Subject: Contract No. NRC-02-84-002, Task Order 007 Document
Reviews

Enclosed please find the reviews of the following documents:

EI DOCUMENT REVIEW SHEET

Figure 1. Comparisons of predicted and measured response after 9 months. Thermocouples are attached to vertical extensometers (a) 1E01 and (b) 1E03 located on opposite sides of the FS#1 main heater.

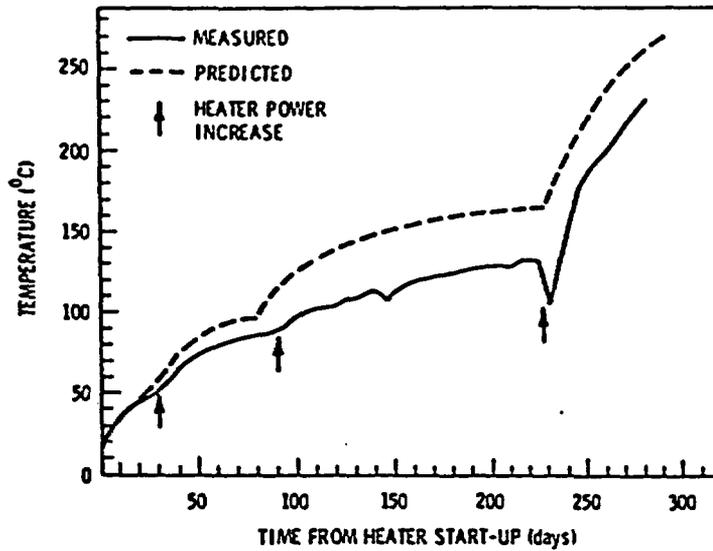
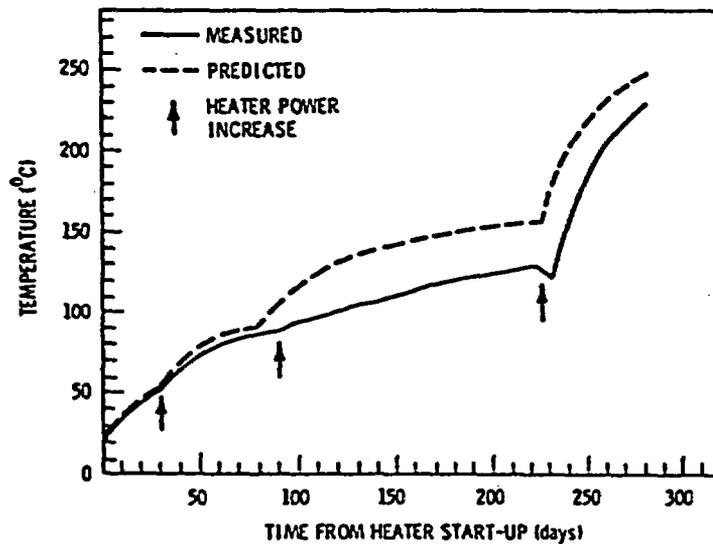
The temperature distributions are given in Figure 1. Measured temperatures are generally 20 to 25% lower than predicted. Temperature changes are influenced by water infiltration. Water infiltration generally lowers the temperature, and temperature increases correspond to increases in heater power levels and dewatering.

1. The test environment is not what is to be expected at the repository horizon due to great depths, higher stress environment, changed water conditions, and greater confinement.
2. The water flow patterns in FS # 1 and FS # 2 are that mainly of surface water (above the water table) as opposed to groundwater below the water table that is expected in the repository horizon.
3. The emplacement configuration in the test is vertical, whereas the present repository design calls for horizontally emplaced canisters. Therefore the heat distribution may be significantly different.
4. The computer code used for predictions is not available for review.
5. Heater tests are necessary in the at depth test facility.

Figure 1. Crusher Chamber Top Slice (1605m Level).

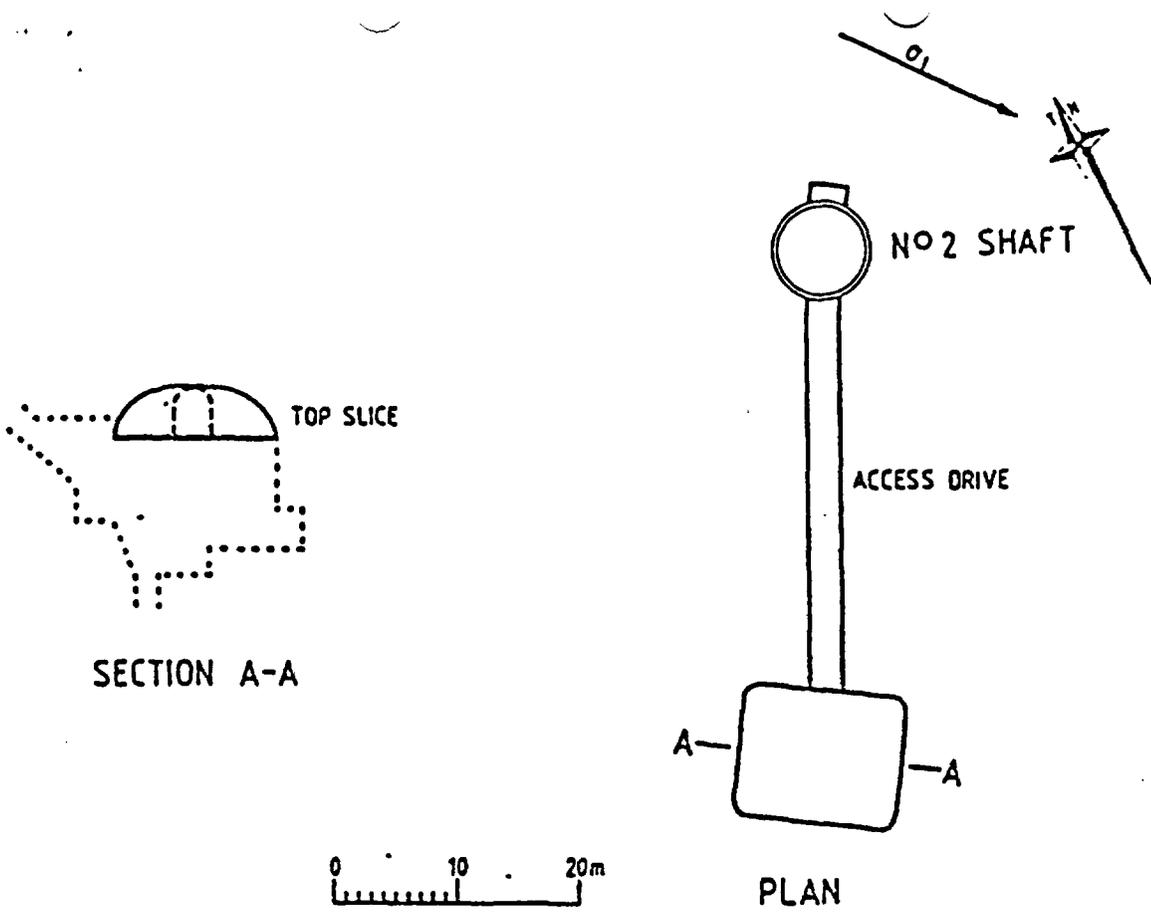
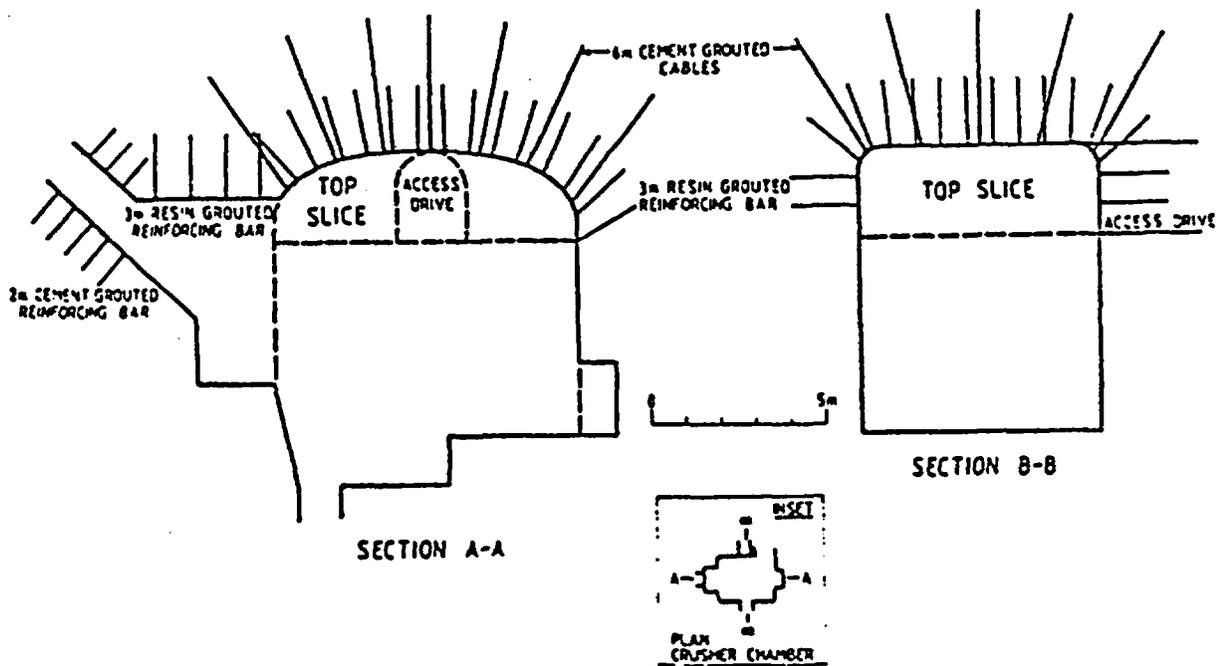
1. This document is partially applicable to BWIP due to the biaxial stress condition, however the size of the excavation is much larger than those planned at BWIP.

2. BWIP is going to experience severe problems in excavating drifts perpendicular to the maximum horizontal stress. A special problem may arise in keeping the storage holes open until canisters are emplaced.
